ENGINE - MAIN GEARBOX ASSEMBLY - PROVIDE AN IMPROVED FRONT DEOILER BALL BEARING AND A NEW HOUSING - CATEGORY CODE 5 - MOD.ENG-72-0244

International Aero Engines

SERVICE BULLETIN

Fig.1

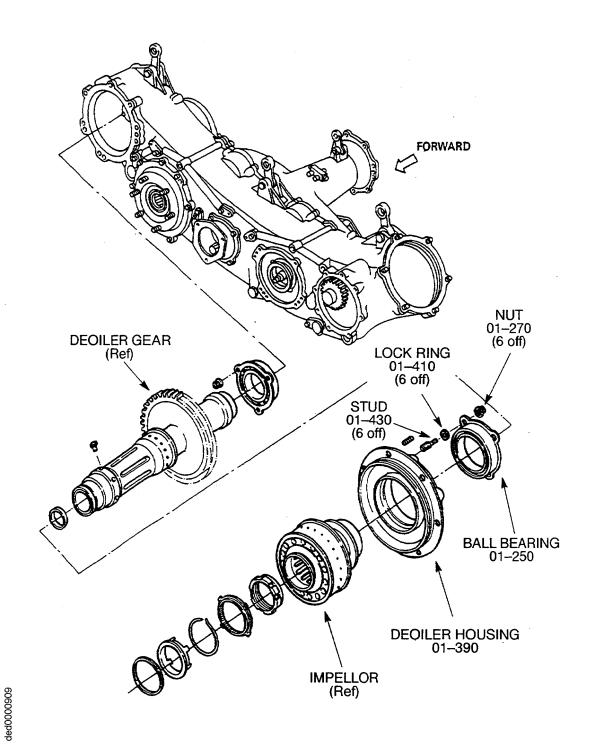
The material of the bearing cage is changed from bronze to steel and the material of the balls, inner and outer races is changed from 100CR6 to M50(AMS6491)

The flanges of the ball bearing outer race and bearing housing are modified to increase the number of the attaching points from 3 to 6

- C. Assembly Instructions. See Figure 1
 - (1) Install the new ball bearing in the new bearing housing by the approved procedure in Reference (3) Chapter/Section 72-60-29, Assembly .

- (2) Install the six nuts which attach the ball bearing outer race to the new bearing housing. Torque to 85 to 95 lbfin. (9,604 to 10,734 Nm).
 - (3) Install the new bearing housing with the new bearing on the deoiler gear by the approved procedure in Reference (3) Chapter/Section 72-60-29, Assembly
